REGULATORY COMPLIANCE REPORT

**SUBDIVISION
PRELIMINARY
PLAN:**

ANDERSON 22-04

WATERFRONT ESTATES AT COLDSTREAM

PROPOSED SUBDIVISION PRELIMINARY PLAN

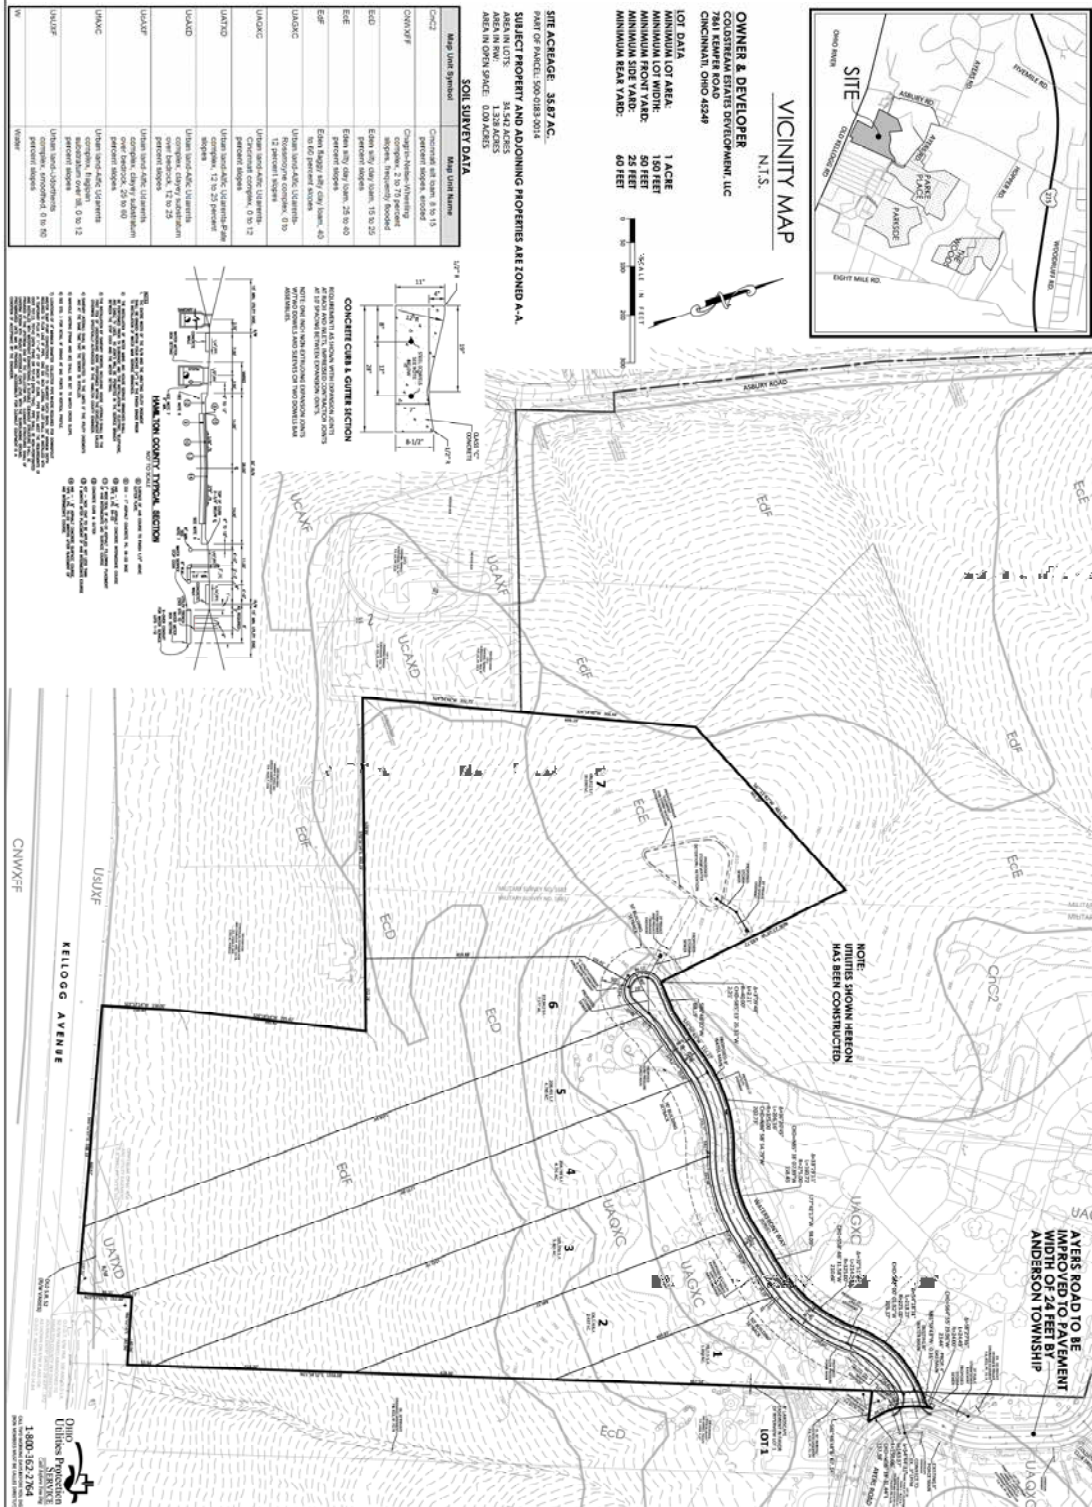
- The street is built to public street standards with 28 feet of pavement width within 50 feet of right-of-way.
- Sidewalks are proposed along both sides of the new road but not along the Ayers Road frontage which is required in the Hamilton County Subdivision Regulations.

- Section 12.3.10 (a) Residential Streets – Cul-de-Sacs; Stubs – Cul-de-Sacs Having Single Public Access - states that a cul-de-sac, series of cul-de-sacs or any other combination of permanent dead-end streets shall not provide access to more than 30 lots, provided, however, that the Planning Commission may approve a subdivision or the extension of a street which will result in frontage to more than 30 lots having only one access, upon making the findings and conclusions that justify the number of lots relative to the 15 factors listed in Section 12.3.10 (a) of the Subdivision Regulations. Staff reviewed these 15 factors in March 2021 and offers similar findings in Attachment A (see page 8).

- With the addition of 7 lots and the additional 26 lots from the Carriages of Coldstream, the applicant is again requesting a modification for a total of 114 lots (number modified per Appendix A) accessed off a series of cul-de-sacs with no emergency access.

12. Availability of alternate emergency access: **It does not appear that an emergency access point is feasible due to severe steep slopes.**
13. Traffic as measured by average daily trip (ADT) rate: **N/A**

RECOMMENDATION: APPROVAL
